## NBH – South Terminal

### EPA Questions and Comments Following Review of the Commonwealth's June 18, 2012 Submission

## Responses to USEPA's 6/26/12 Questions

DRAWING NO.  
**P-2.2**

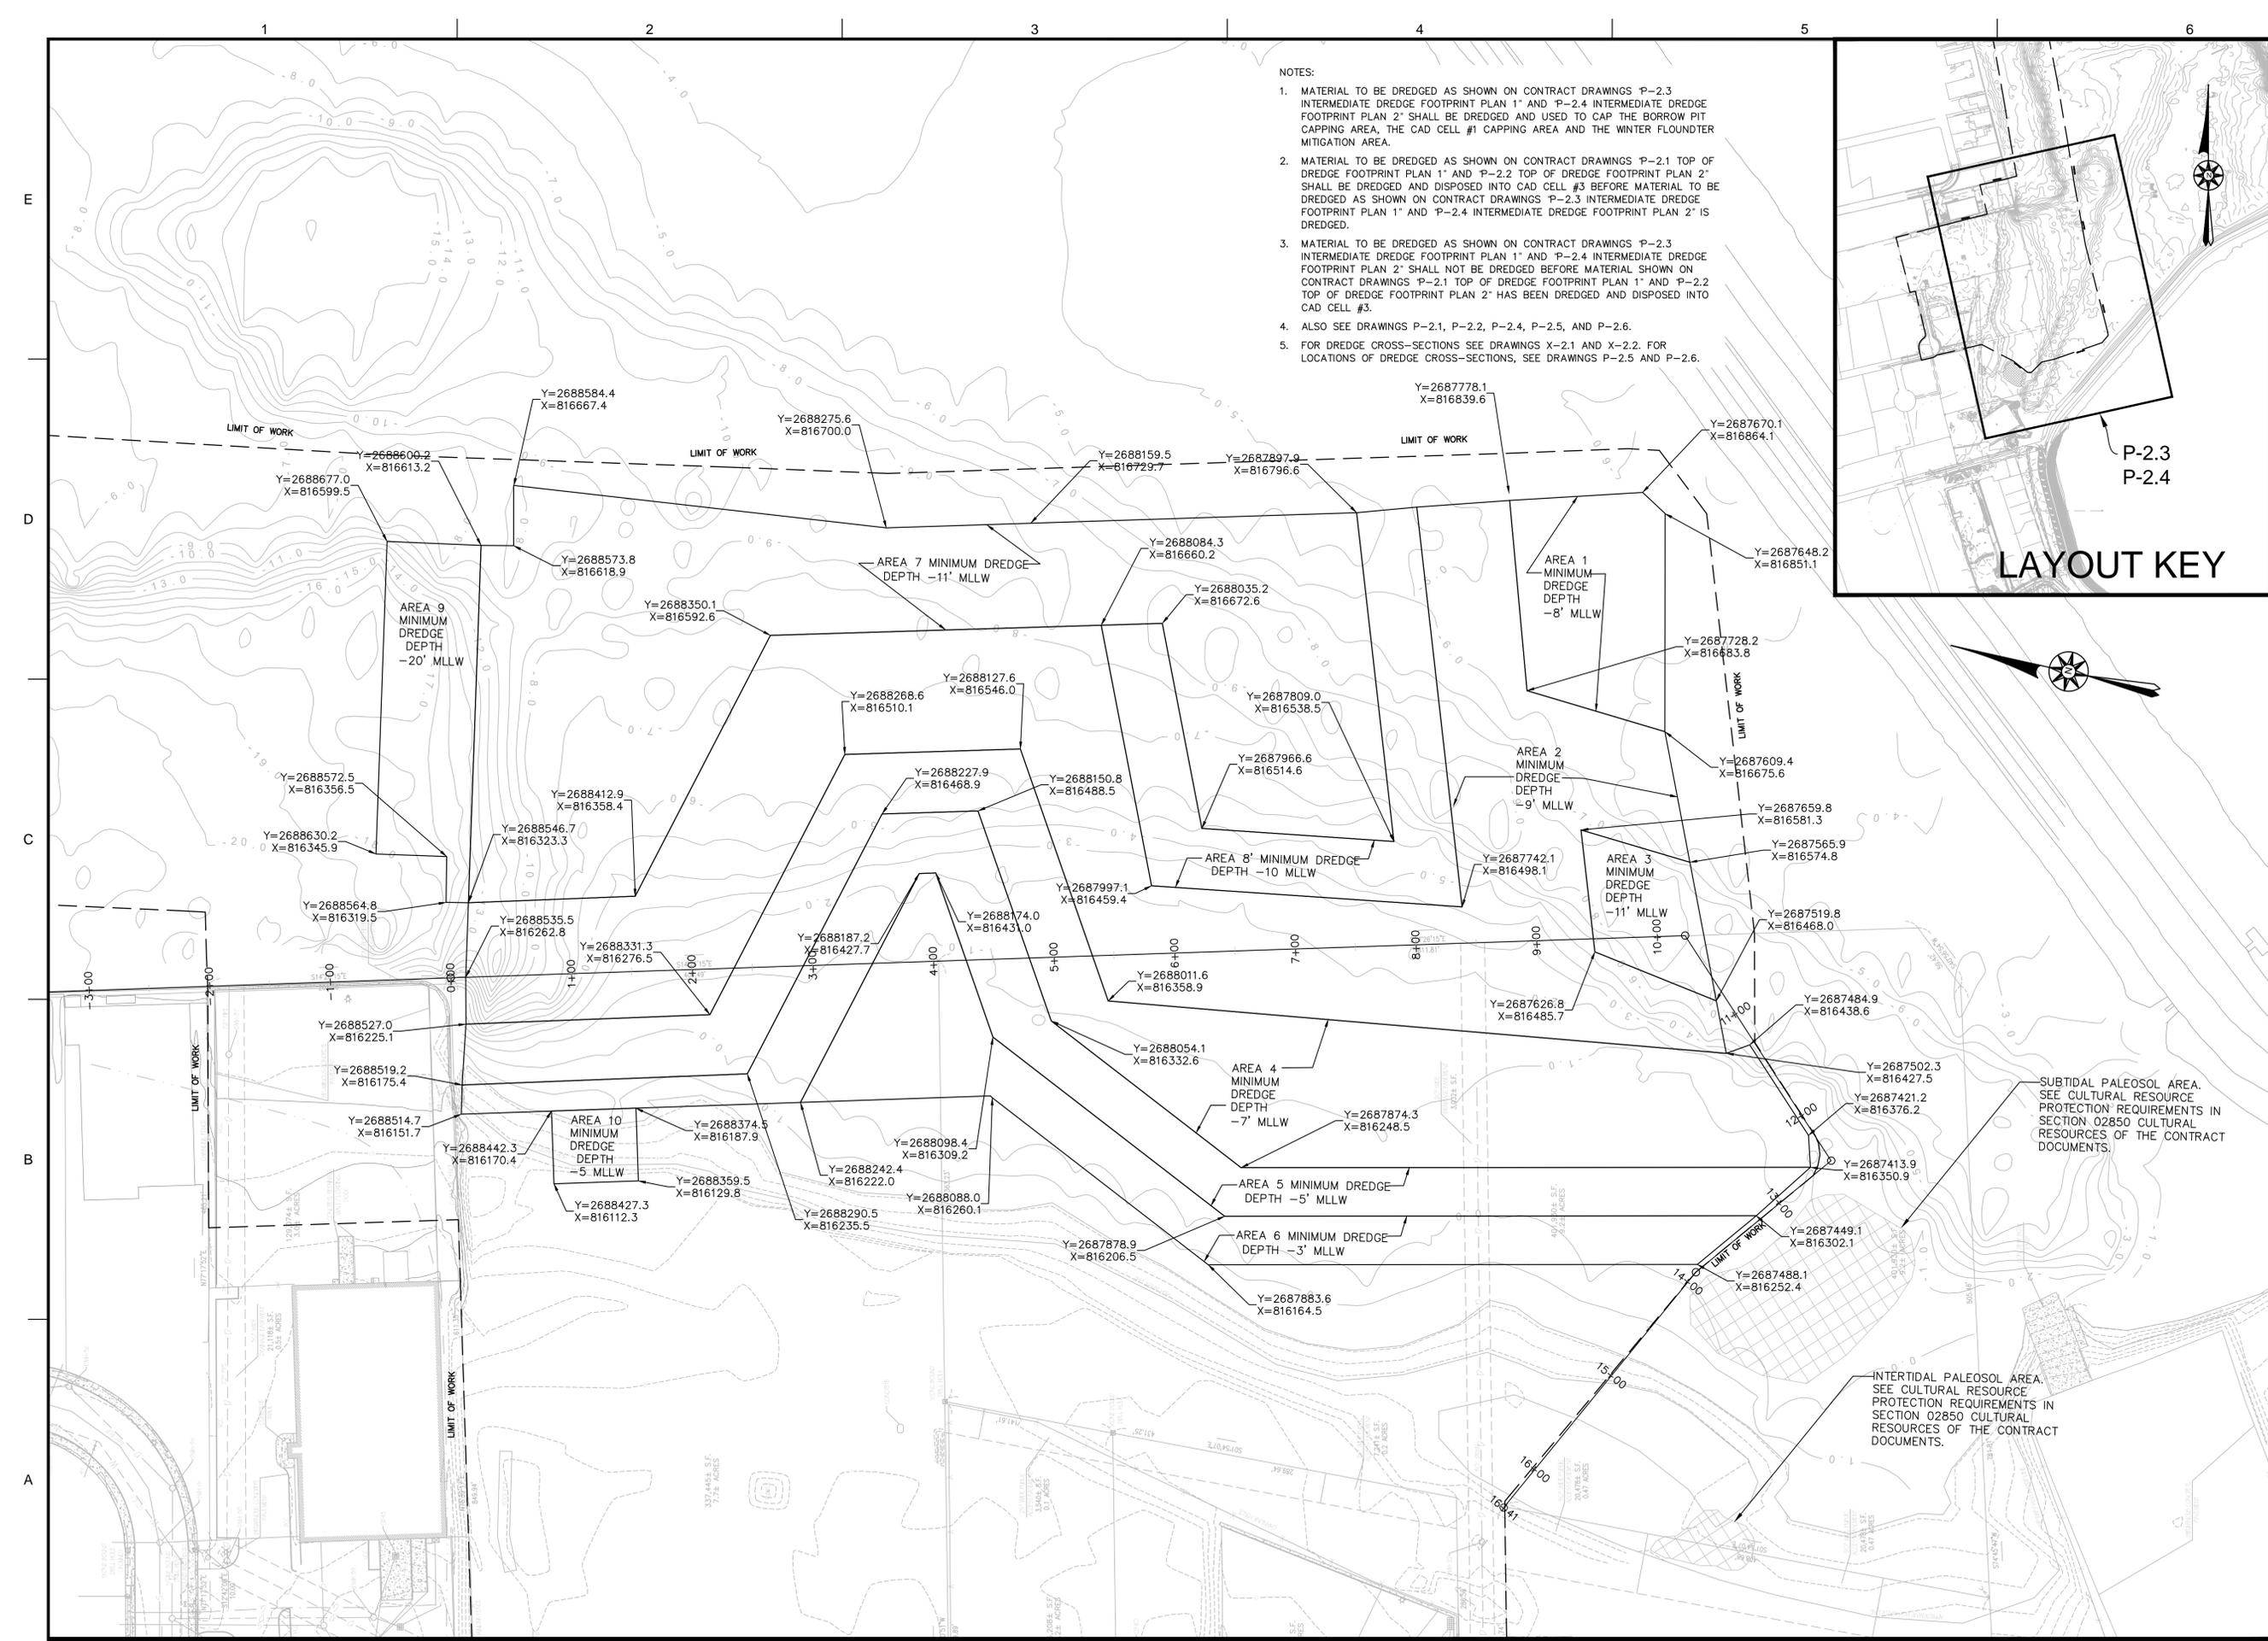
1. **Question:** Please provide a detailed description of the newly proposed project revisions, including engineering plans and elevations (cross sections) showing the revised project design, including the expanded deep draft quay-side areas, the new 50 foot expansion of the navigational channels, the resultant expansion of CAD cell #3, the reduced northern mooring area, the expanded winter flounder spawning habitat creation area, the expanded OU-3 capping mitigation area, and any other changes or revisions proposed for the project that are not reflected in the current plan sets and figures. Figures 2, 5, 10, 11 and similar figures representing the proposed project should be updated to include all revisions.

**Response:** The revised plans for the project include engineering plans for the expansion of the winter flounder spawning habitat creation area, the expanded OU-3 capping mitigation area, and the reduction in the mooring mitigation dredge area. Updated plans outlining the potential expansions/reductions for these proposed work elements are attached as **Attachment A**. The channel expansion and deep-draft expansion items noted in the plans represent construction elements that are not part of the currently proposed facility plans and currently are not expected to be constructed, but could become contractual alternate add-ons in the future. Updated engineering plans outlining the potential expansions of the proposed work for the possible channel expansion and expansion of the deep-draft area have been created and are also attached in **Attachment A**. These attachments show the proposed outlines of the areas that the Commonwealth would anticipate impacting should the Commonwealth implement any of the optional items that were presented for EPA's consideration within the Commonwealth's June 18, 2012 submittal to EPA. The plans include:

- Alternate plans P-2.1, P-2.2, P-2.3, P-2.5, and P-2.6 which show the draft plans for the Top of Dredge, Intermediate Dredge and Bottom of Dredge, should the Commonwealth decide to pursue both the expanded channel and expansion of the deep-draft area at the terminal to the north and south.

DRAWING NO.  
**X-4**  
DRAFT

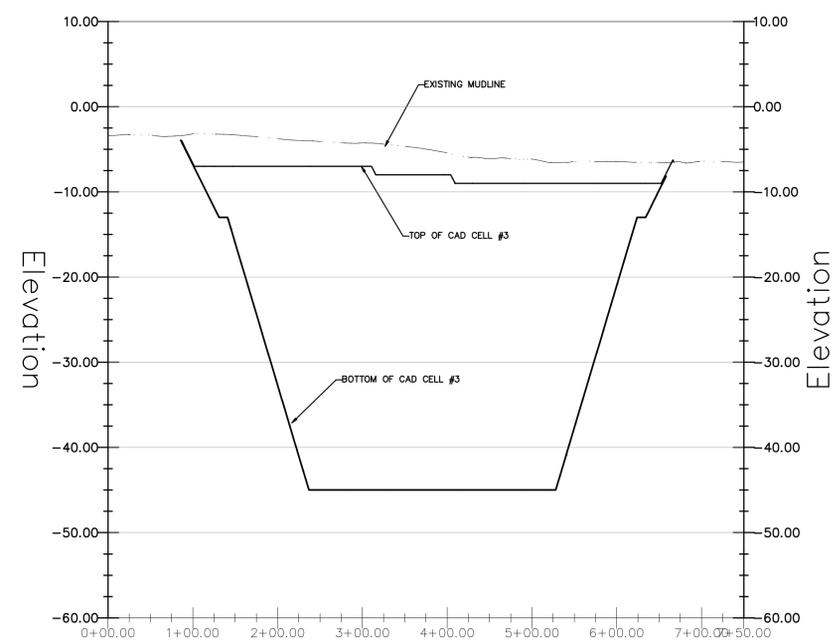
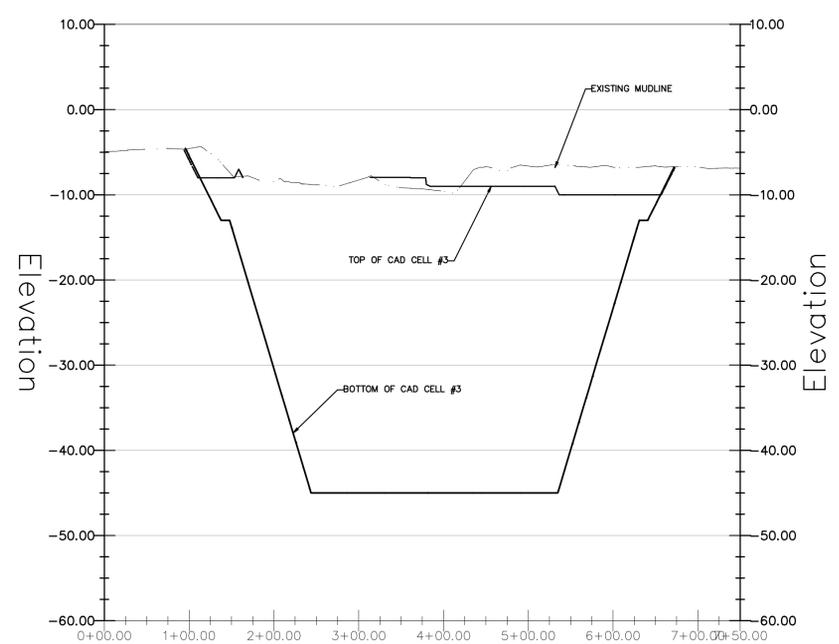
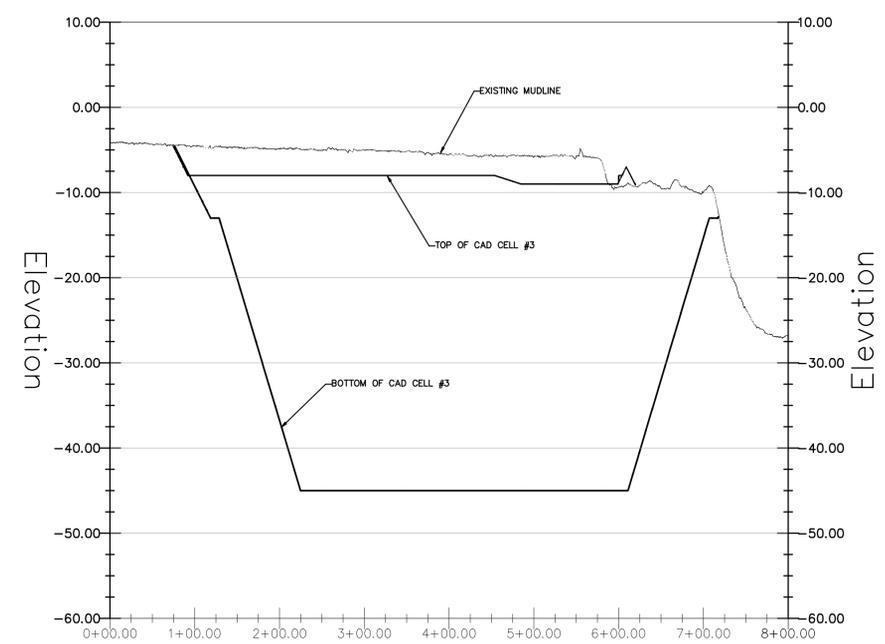
5. **Question:** According to page 10, the size of the CAD cell is unchanged from the January 18, 2012 submittal. However, page 28 refers to “associated increases in the size of CAD cell #3 to accommodate additional impacted dredge spoils for disposal.” Please describe how much larger the CAD cell will be, what additional impacts will result from its expansion, and what additional mitigation is proposed.

- Alternate plans P-13, P-14, P-26, and X-4 which outline the largest anticipated configuration for CAD Cell #3. Please note that this largest configuration for CAD Cell #3 was the basis for the Commonwealth's determination that the resource area impacts for CAD Cell #3 would be 8.76 acres. The CAD Cell #3 design included within the Commonwealth's responses to EPA questions submitted on June 18, 2012 contained a smaller configuration for CAD Cell #3, one which did not include the potential increases in size to the channel or

**Response:** The 8.76 acre impact area associated with CAD Cell #3 listed on page 10 of the Commonwealth’s June 18, 2012 submittal to EPA (8.76 acres) is based upon the anticipated largest CAD Cell that would potentially be constructed in association with the anticipated work. While this larger (8.76 acres) CAD Cell is not part of the current project plans, it is possible that the larger CAD Cell may be needed if other project alternatives become realities, and therefore the design for the larger CAD is being submitted for EPA’s consideration. The design for that larger CAD Cell is attached to this document as **Attachment A**, which includes designs for Top of CAD #3, Bottom of CAD #3, Cross Sections, and a CAD #3 disposal plan for the largest CAD Cell anticipated by the Commonwealth, which, again, is correlated with the 8.76 acres of impact.

The design forwarded to EPA as Attachment A to the Commonwealth’s June 18, 2012 response to EPA Questions is a smaller CAD Cell, associated with the 600 foot deep-draft quay-side, 175 foot wide channel, and 100 foot wide tug channel (without dredging in the Federal Channel). That design of CAD Cell #3 correlates to a smaller area of impact (approximately 6.3 acres).

The current proposed mitigation associated with this project assumes that the larger (i.e. 8.76 acre) CAD Cell will be constructed, even though the Commonwealth currently anticipates that only the smaller (i.e. approximately 6.3 acre) CAD Cell will be constructed in association with this project. Therefore, the Commonwealth does not anticipate a larger CAD Cell impact than the 8.76 acres stated on page 10 of the Commonwealths June 18, 2012 submittal and therefore no additional mitigation is proposed.

SHEET TITLE:	
SCALE: 1"=50'	DATE: JUNE 2012
PROJECT MANAGER: CAW	
PROJECT ENGINEER: CF	
CHECKED BY: CC	SHEET No.
DRAWN BY: J	
JOB NUMBER: J11822	<b>C-8</b>

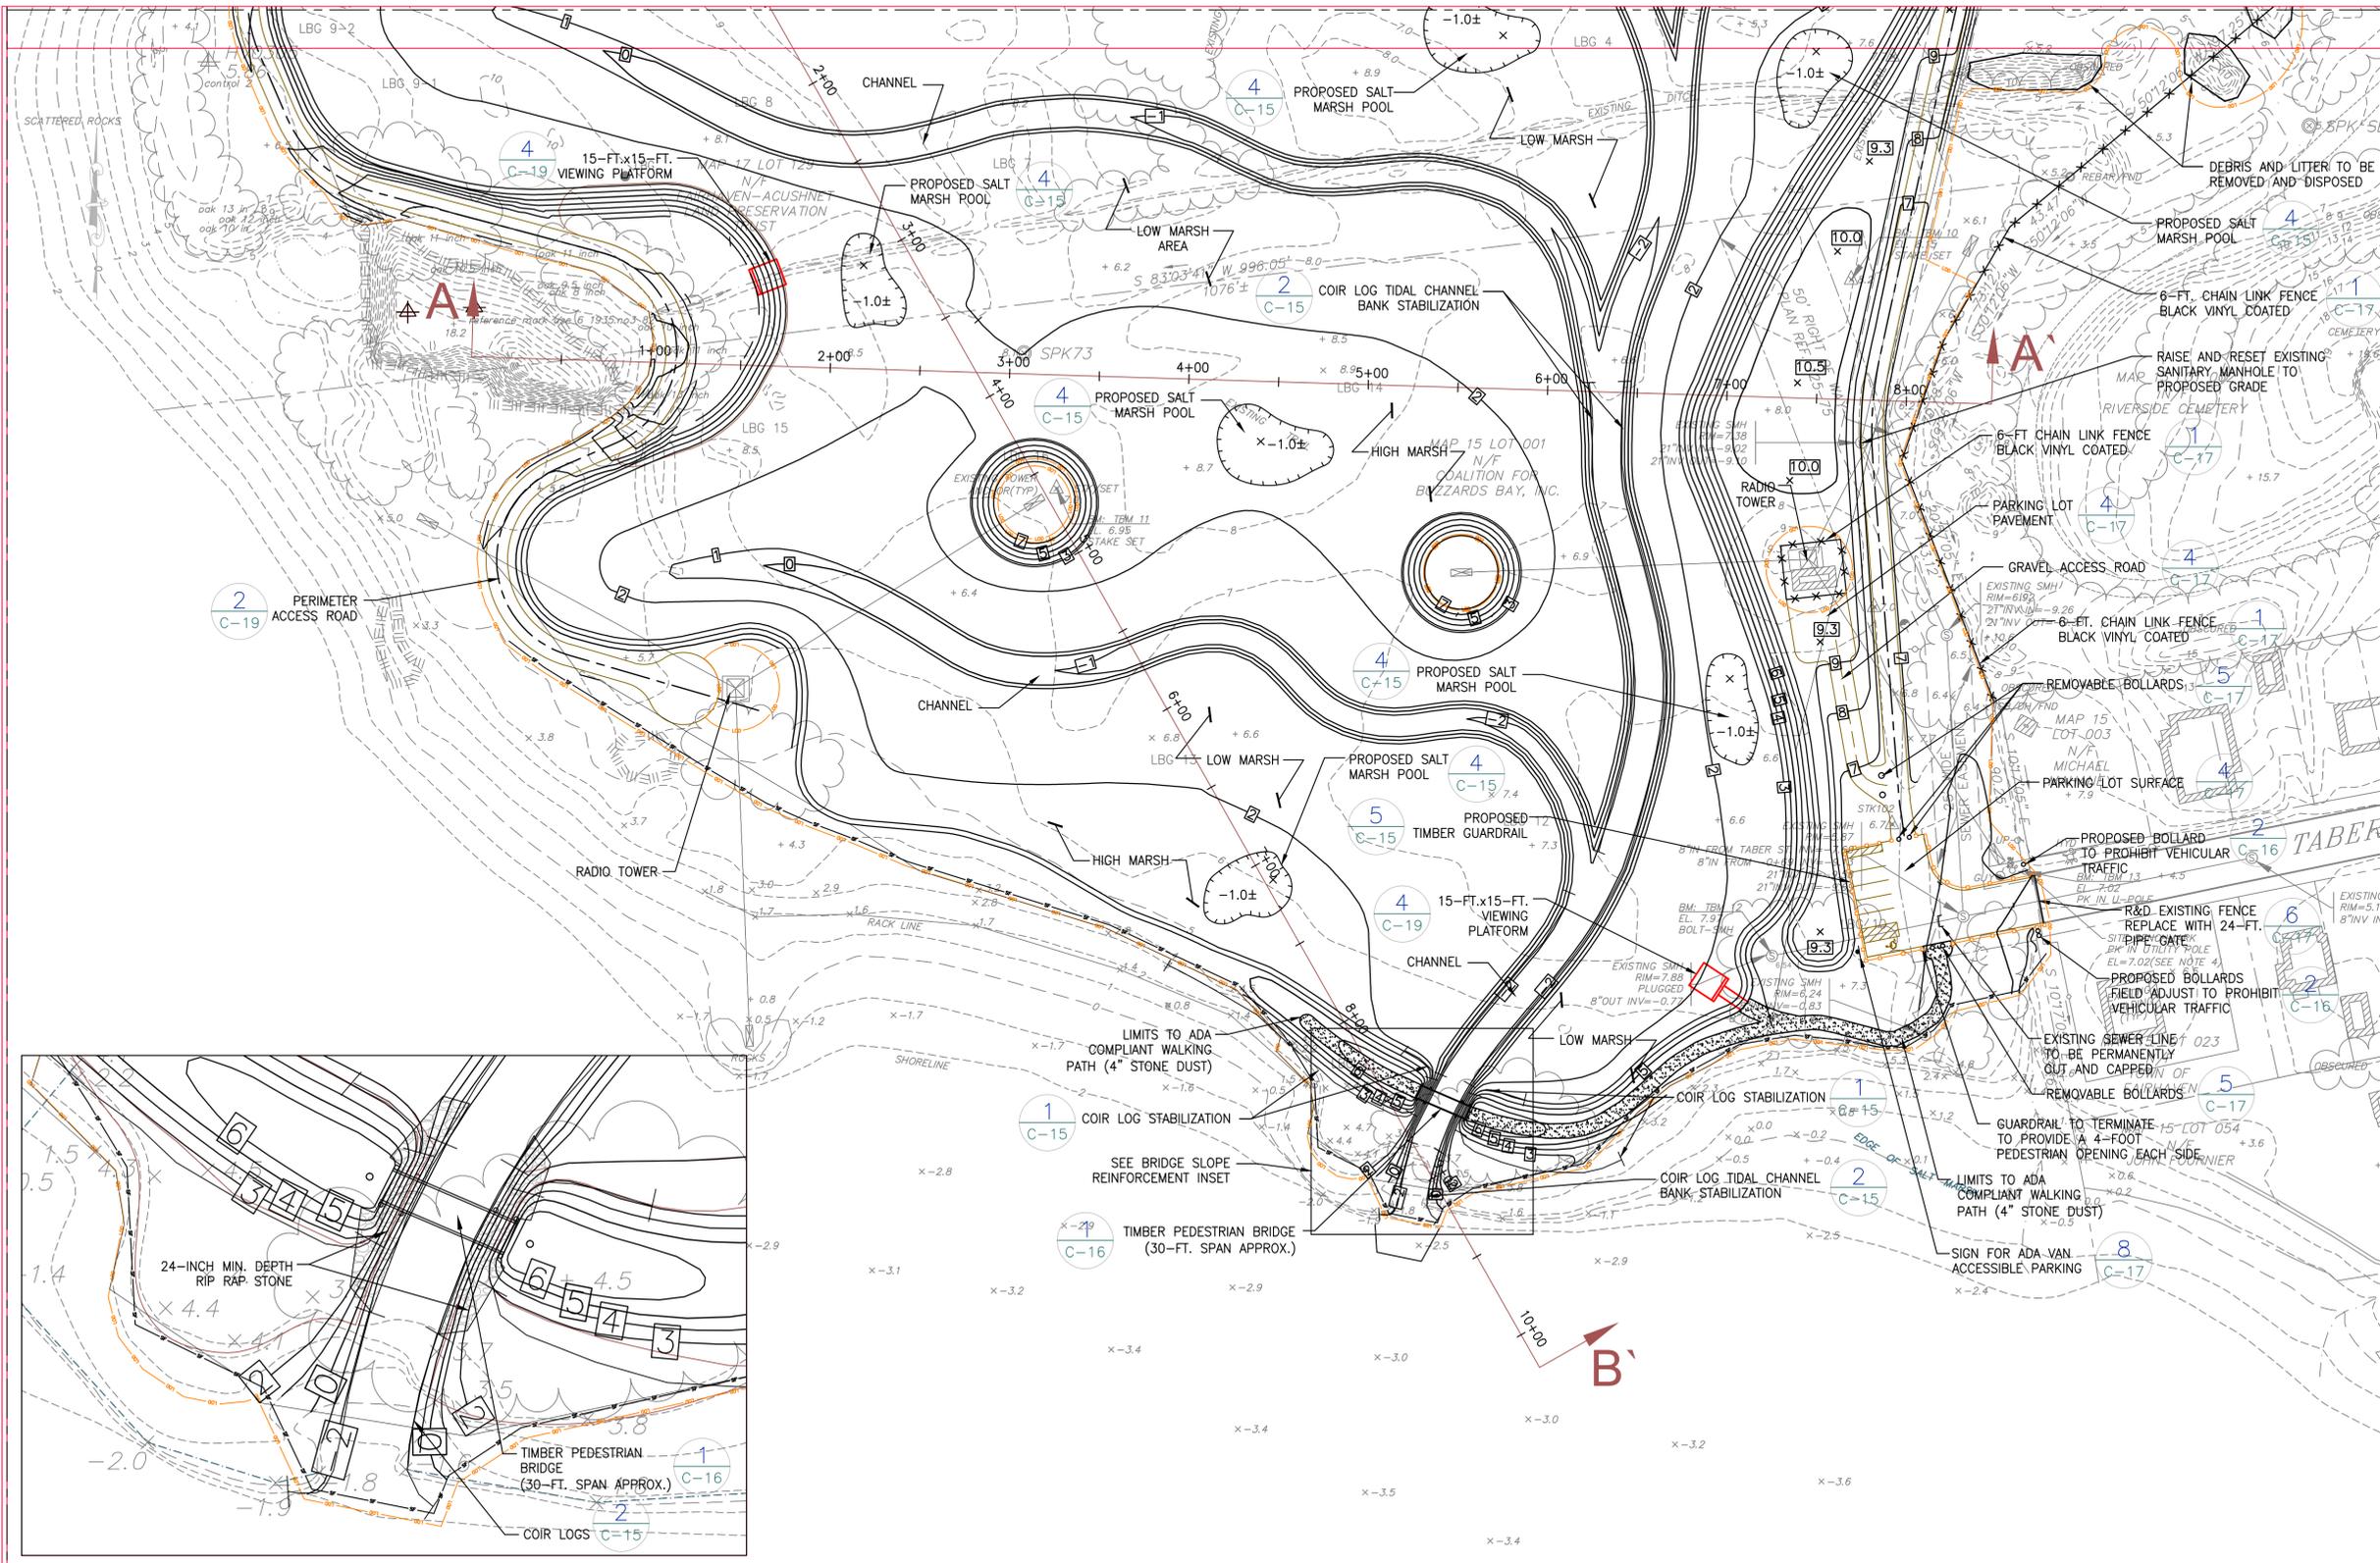
8. **Question:** Regarding the flood storage loss issue, the response on page 42 to Question 7F describes the Marsh Island mitigation project and states that “the final volume of material to be removed from the flood storage band of +2 to +6 NGVD29 is unknown at this time...,” but later states that the “project has been designed and is the process of being permitted.” Please obtain and provide the information necessary to enable an evaluation to be made of the flood storage capacity between +2 and +6 that will result from this mitigation project, or if it is not yet available, state when it will be available. Also please identify when the mitigation work will occur.

**Response:** Plans of the Marsh Island mitigation project design have been collected by the Commonwealth and are included in **Attachment B**. The Commonwealth has analyzed the pre-construction elevations, and compared them to the post-construction planned elevations in NGVD 29. Based on the information contained within the plans, the volume of material to be removed from the elevations of +2 to +6 NGVD 29 in association with the Marsh Island mitigation project is approximately 64,000 cubic yards. The increase in flood storage capacity within New Bedford Harbor between +2 and +6 NGVD 29 that will result from this mitigation is 39.67 acre feet. The Marsh Island mitigation project has a projected start date of the Spring of 2014. The construction is proposed to be completed one year from ground breaking.
